# PIMA ROAD THREE BASINS PROJECT

MISCELLANEOUS DESIGN MEMORANDUMS

**Subject:** **Pima Road Three Basins Project**  
**Tract 21 Drainage**  
**Design Memorandum**

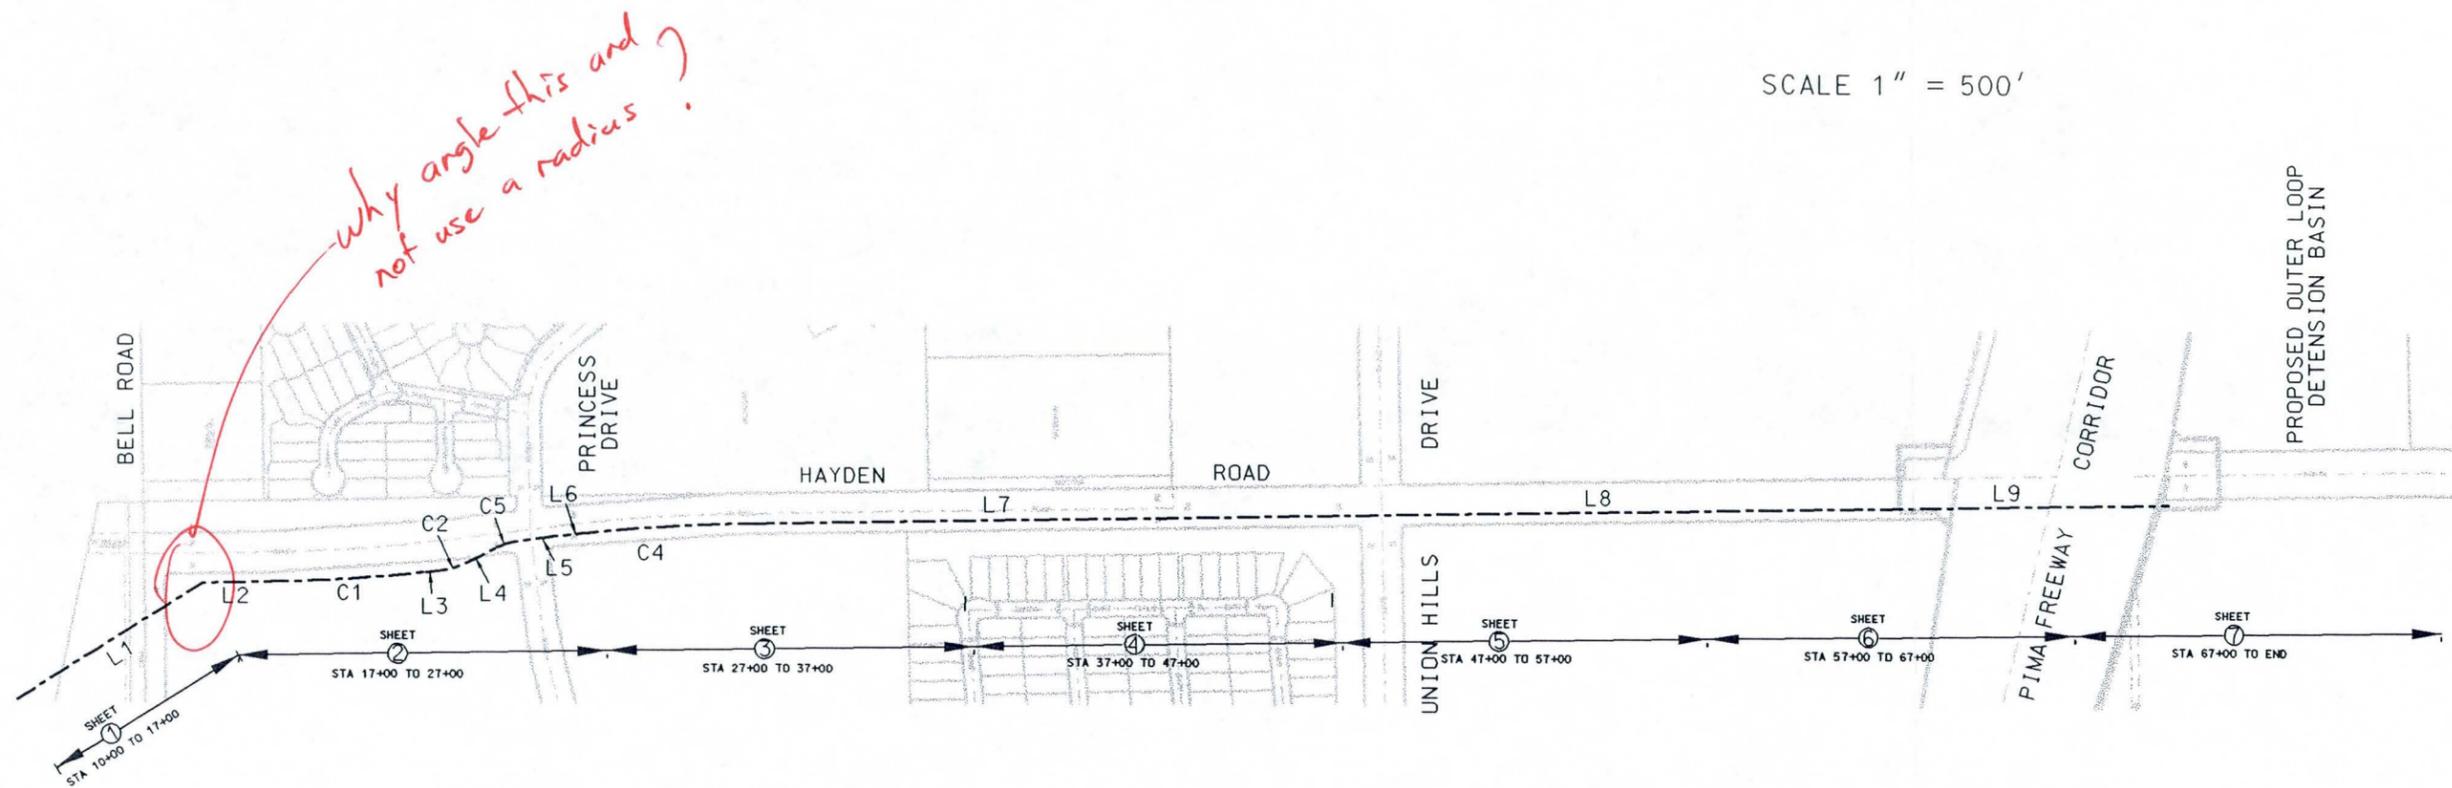
*Exhibit A shows 1531.0*

*which one is correct?  
Also, will an energy dissipation structure cause a greater impact on the tailwater condition?*

*Need to include summary of jet loss coefficients used if any. seems like the losses at the "junctions" are excessive  
Also, did you include an entrance loss at I-1*

DATE	REVISION	BY
ENGINEER		
TRANSPORTATION DEPARTMENT TRANSPORTATION PLANNING 3939 CIVIC CENTER BLVD. SCOTTSDALE, ARIZONA 85251		
PROJECT TITLE HAYDEN ROAD STORM DRAIN		
SCALE	DESIGNED BY/DATE AS-BUILT 4/16/98	BID NO. 5001.0007
	DRAWN BY AS-BUILT	SHT. 1 OF 9

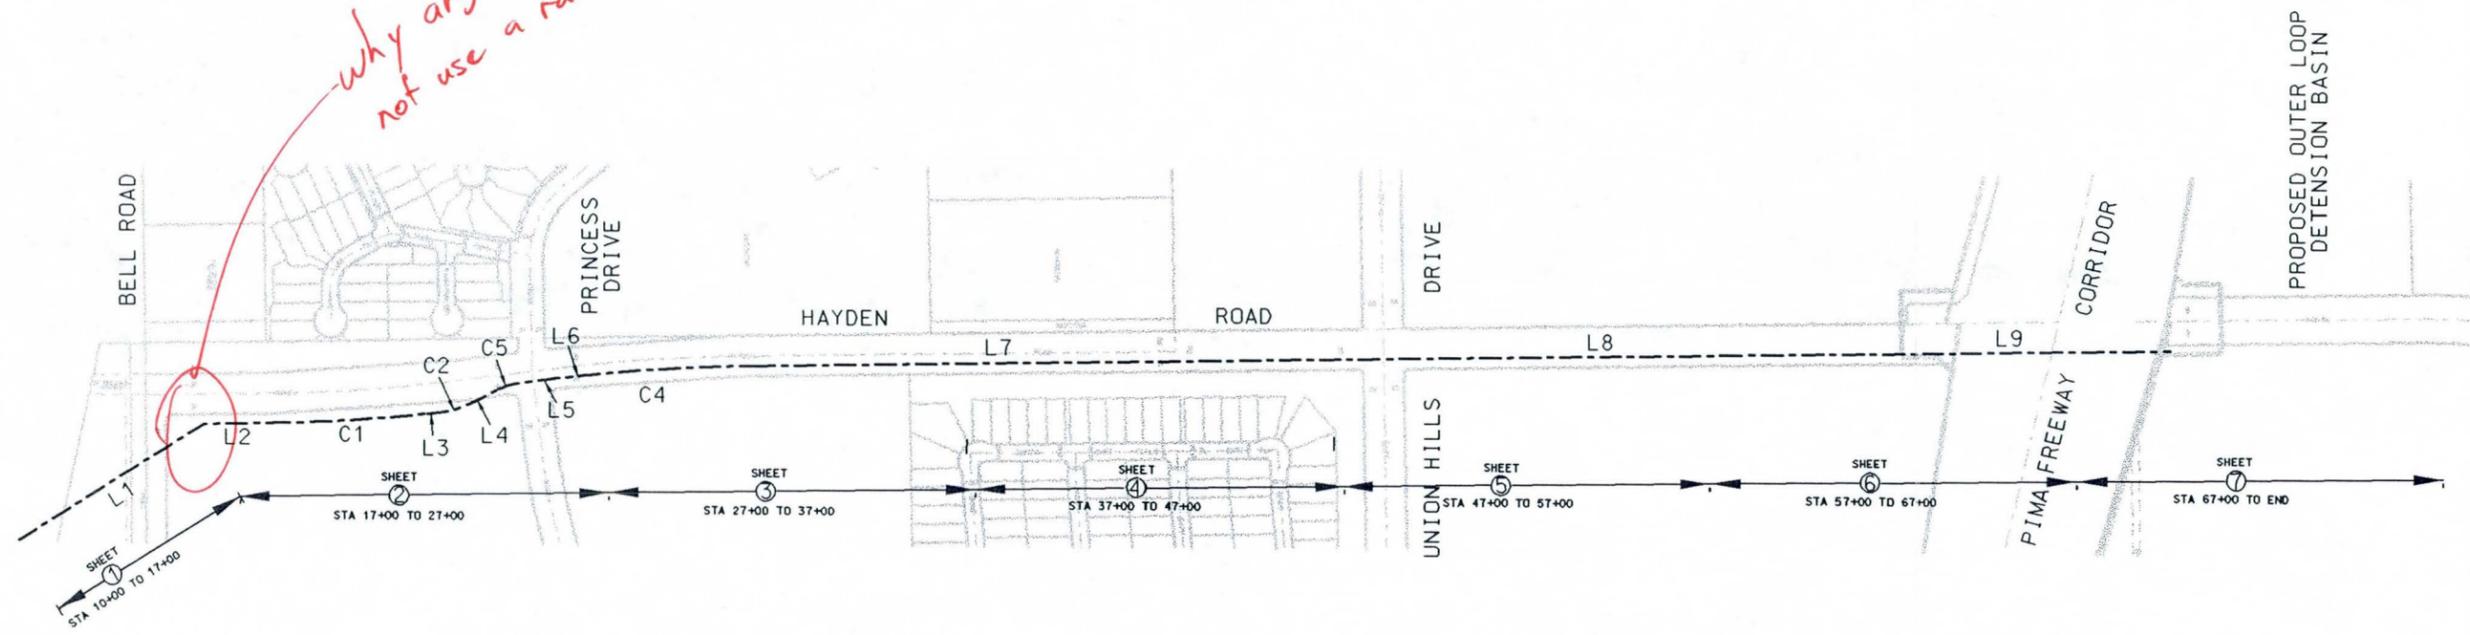
*why angle this and not use a radius?*
